WATER PERMIT NO. 6723-3

Application For Permit To Appropriate Water Within The State Of South Dakota

We have reviewed the plans and specifications for your dam project located in the SE ¼ SW ¼ of Sec. 8-T121N-R50W, in Grant County. The plans and specifications for the construction of your dam are approved. Approval of the plans and specifications does not authorize construction of the dam. The construction of the dam may not begin until Water Permit No. 6723-3 is approved.

REPORT ON
WATER PERMIT APPLICATION No. 6723-3
Marie O'Farrell
June 9, 2006

SKETCH PLAN OF DAM AND RESERVOIR AREA

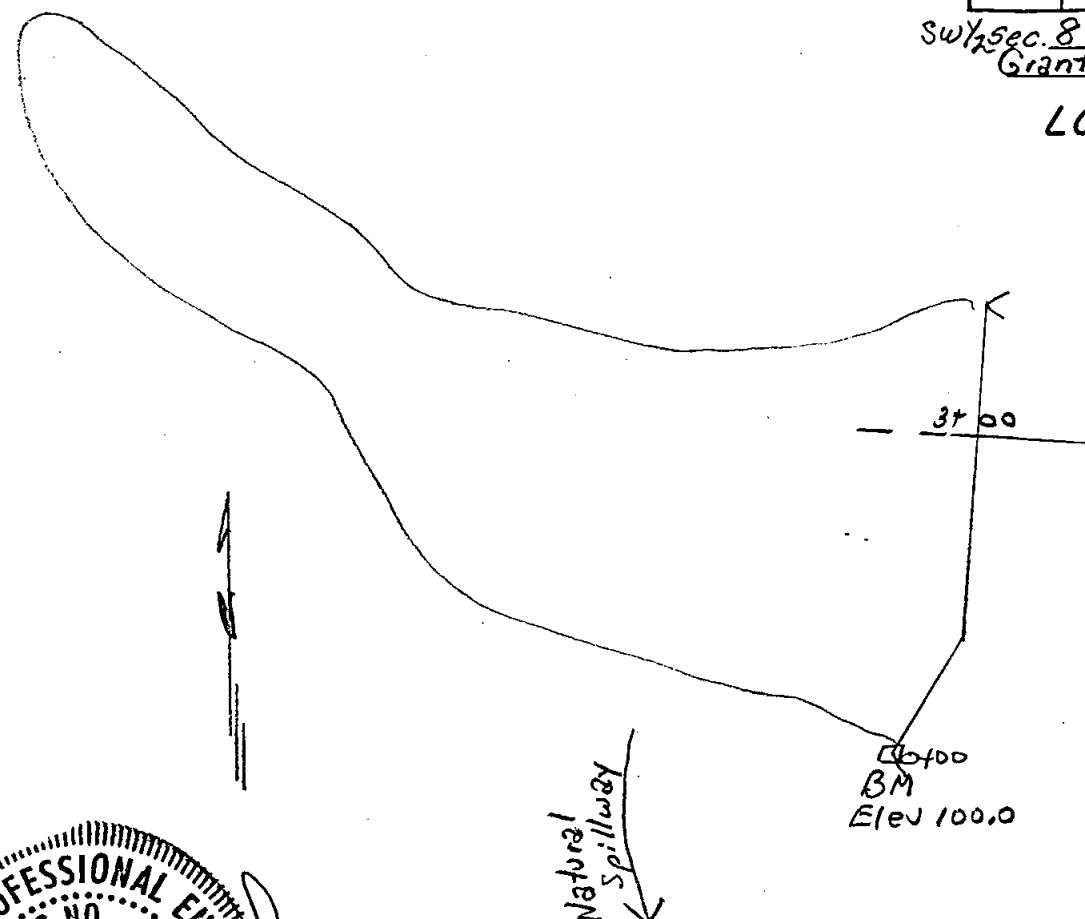
1. Topo Map - OK
2. Dam Axis Profile - OK
3. Dam Max X-Sec. - OK
4. Area Capacity - OK
5. Outlet Details - OK
6. Spillway Rating - OK
7. Spillway Details - OK
8. Specs - std NRCS - OK
9. EPP - N/A Cat. 3 - OK

TYPICAL CROSS SECTION OF DAM

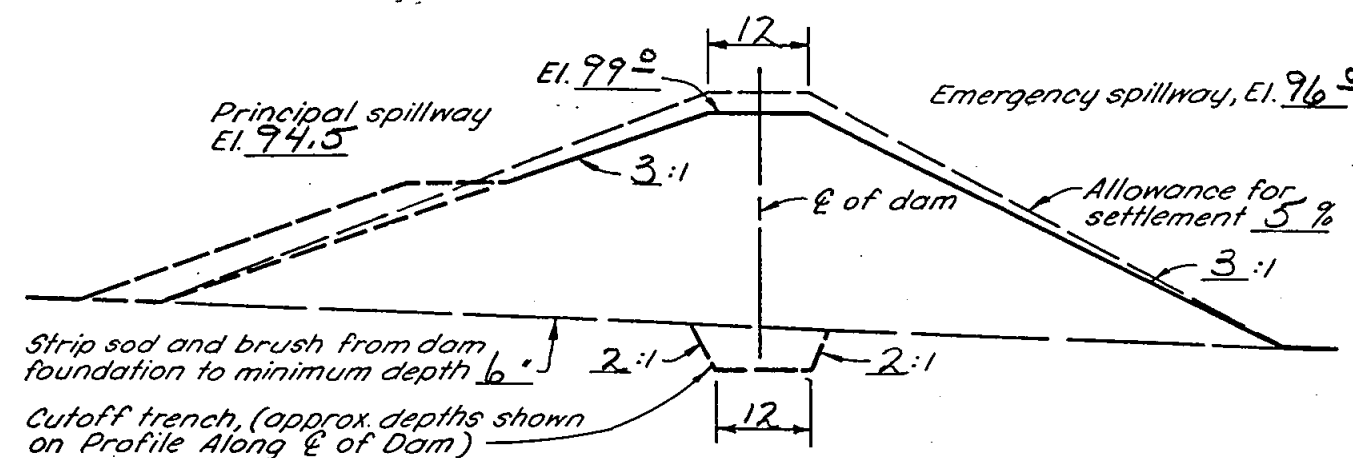
Amount of Water Claimed: ³²
~~38.70~~ AF

I talked to Dave Konechne, from Konechne Engineering, about the storage capacity for the dam covered under Water Permit Application No. 6723-3. He agreed with me that the capacity of 37.8 acre-feet as listed on the application should be changed to 32 acre-feet, since the primary spillway elevation will be at elevation 94.5 (local datum). I told him we would make the necessary change to the application.

The O'Farrell Dam No.2 will be classified as a small size Category 3, Low Hazard dam with a dam height of 19.5 ft. and a normal storage capacity of 32 acre-feet and a maximum storage capacity of 65 acre-feet.
